Appl. No. 10/676,959
Amdt. Dated January 23, 2006
Reply to Office action of November 22, 2005

Amendments to the Drawings:

REMARKS/ARGUMENTS

FIG. 2C

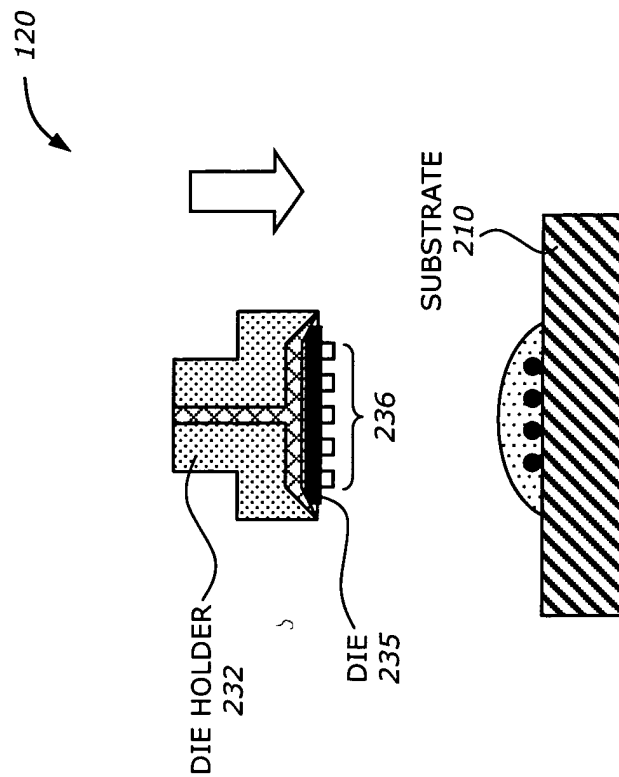
The Examiner objected to the drawings due to minor informalities. In response, Applicant has amended the drawings accordingly as follows:

Figure 2C: Reference "236" is added to show the bumps of the die 235.
